Addendum To: Cadence & Co - REF: 210186.1-A

At the request of Cadence & Co, we provide this addendum as an addition to the Wastewater Management Report (REF: 210186.1-A)

210186.1-B

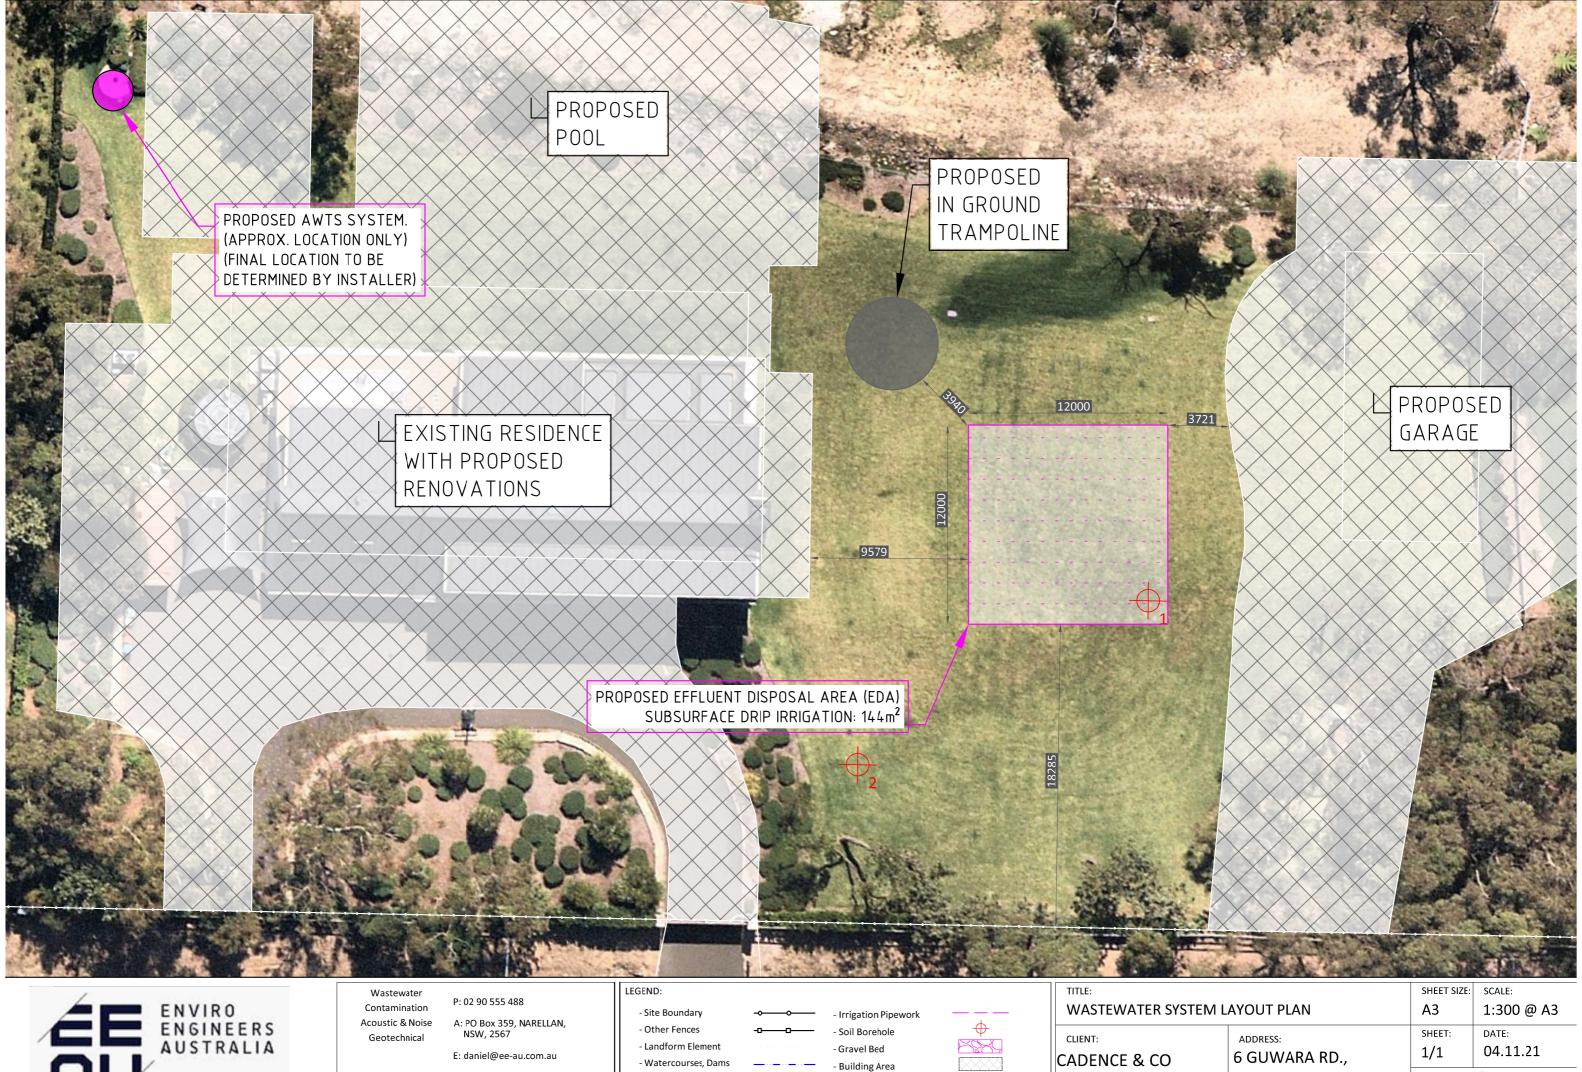
Structure sizes on property have been amended to reflect changes to proposed alterations by client

- REMOVE
 - o 210186.1-A (Wastewater System Layout Plan)
- ADD
 - o 210186.1-B (Wastewater System Layout Plan)

The addendum to the layout plan, is outlined above. This includes the original text and new text, however, will only show the new layout plan with the amended effluent disposal area (EDA). This new layout plan supersedes the layout plan contained within the original report. It is to be referred to when using the plan.
